Subject: FW: Painted Hills TIA Comments

In regard to the September 14, 2016 traffic analysis for the Painted Hills PRD the Washington State Department of Transportation (WSDOT) has completed its review of the analysis. Based on our review we have the following comments that need to be addressed:

INTERSECTION SKETCH

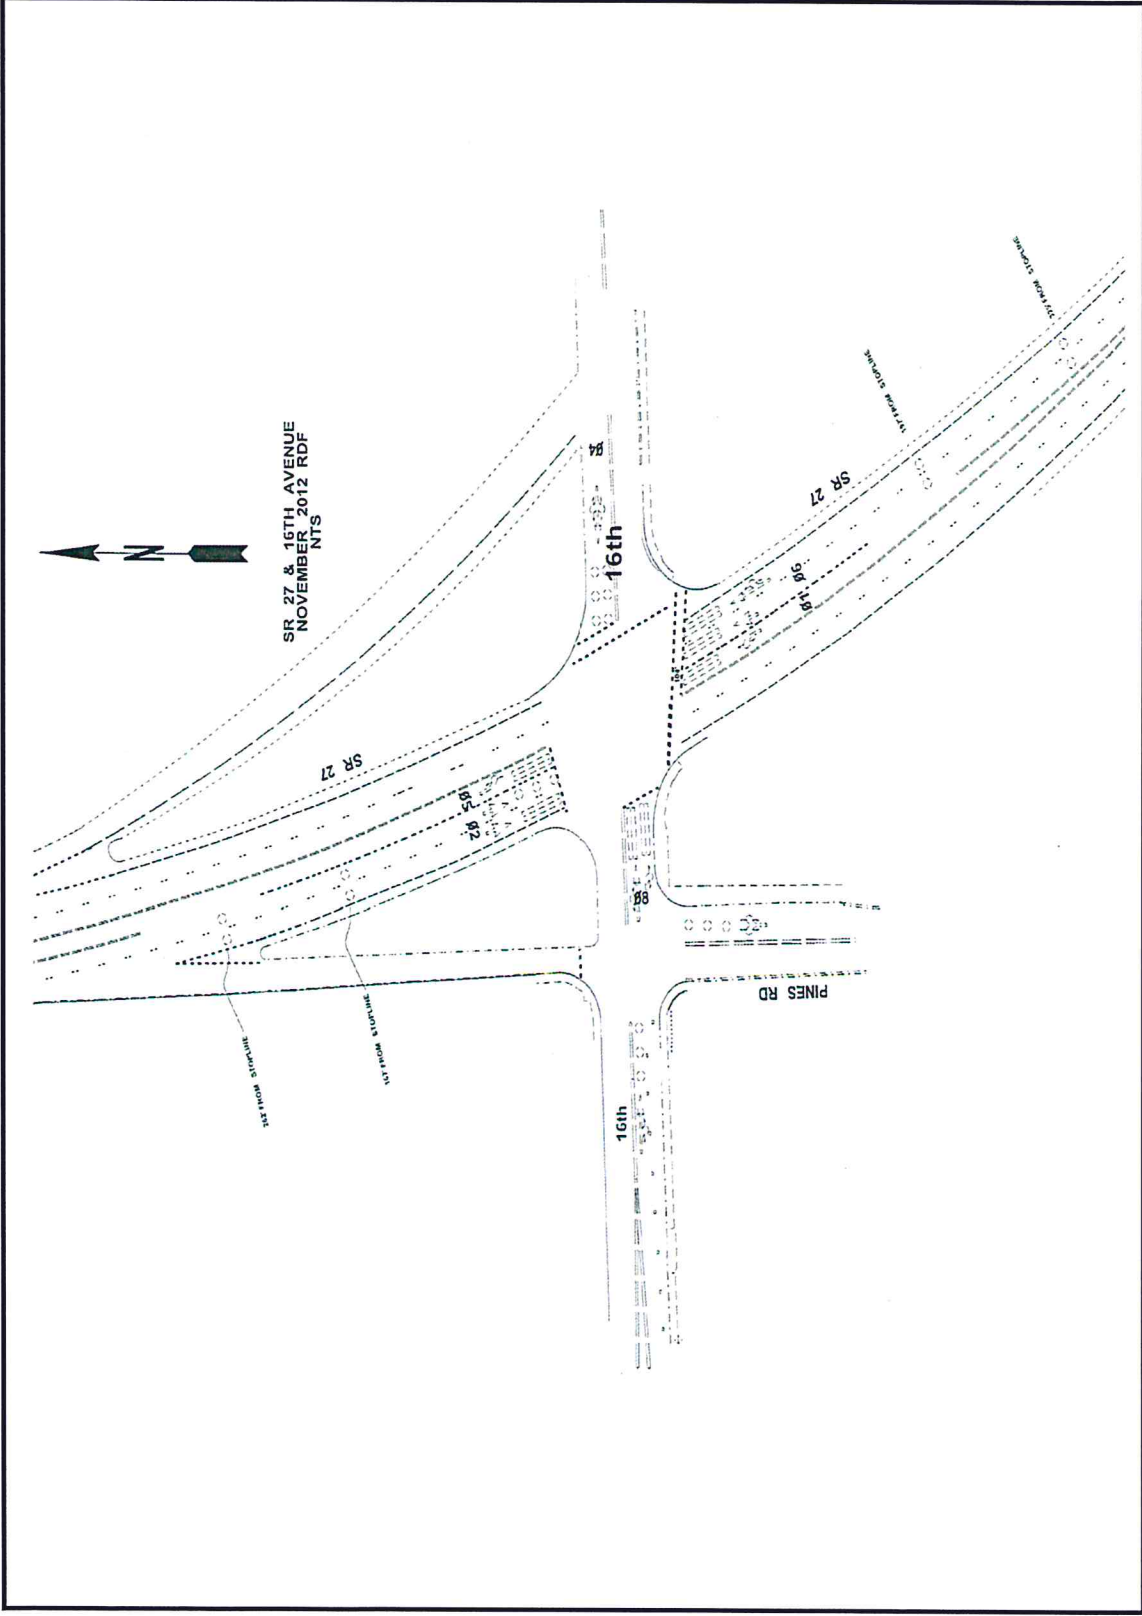
- A Peak Hour factor of 0.85 was used, please explain how it was arrived at.
- Signal timing plan.
 - Under the timing portion for minimum split(s), EBL, EBT & EBR should all be 42.0 seconds, WCE analysis is using 10.0 seconds. There is a pedestrian phase associated with this Eastbound movement, the analysis did not take into account the W+FDW+Y+AR.
 - Detector placement is incorrect, which affects how the signal runs, (see attached).
- Link distance need to accommodate SimTraffic queues. (See node #11 and #12 in pm Synchro file, see attached).
 - Volumes not balanced, therefore, when SimTraffic is ran it does not show realistic queue lengths.
- EB 16th on the west side of Pines is one lane, between Pines and SR 27, EB 16th is 2 lanes and there is one lane for the SB slip ramp from SR 27 to Pines Road. Did not see any language that would indicate restriping or widening roadway.

INTERSECTION SKETCH

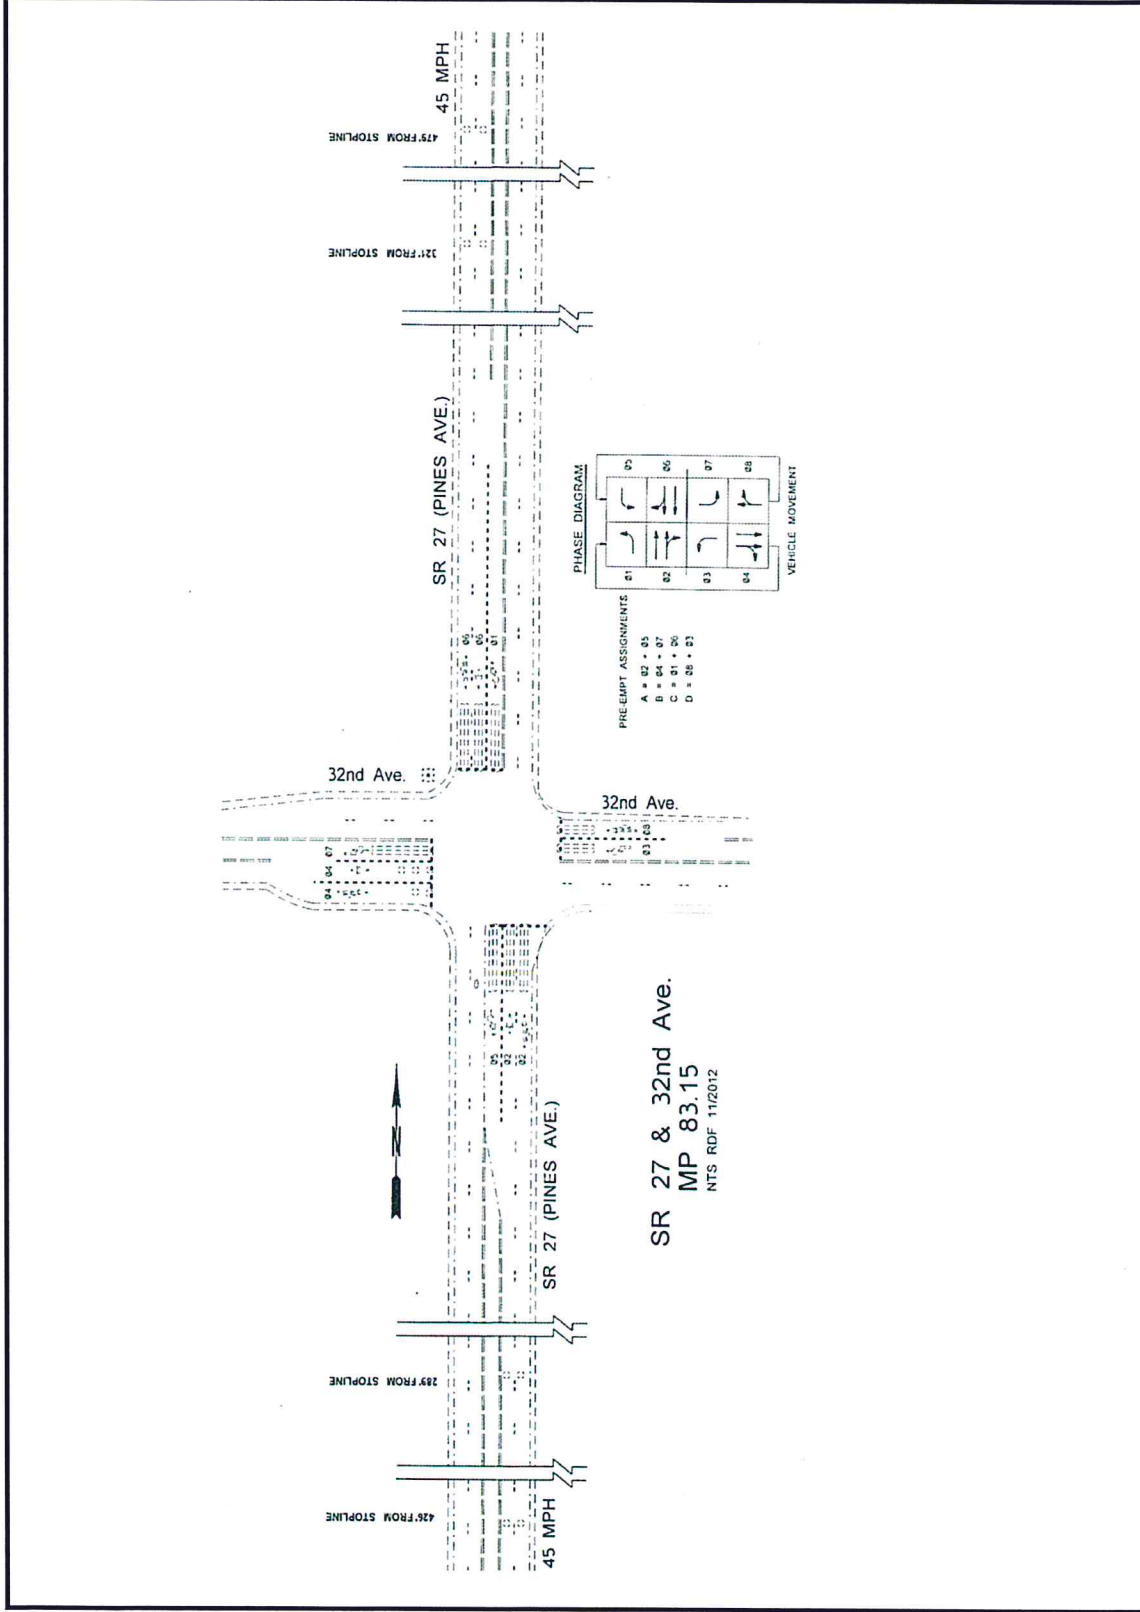
- Timing portion for minimum split(s) EBT, WBT, NBT & SBT need to be adjusted to reflect the pedestrian phase associated with these movements. Total split and Maximum green times are also slightly off.
- Detector placement is incorrect, see attached.
- Add volumes at adjacent nodes to better reflect queuing results in SimTraffic.
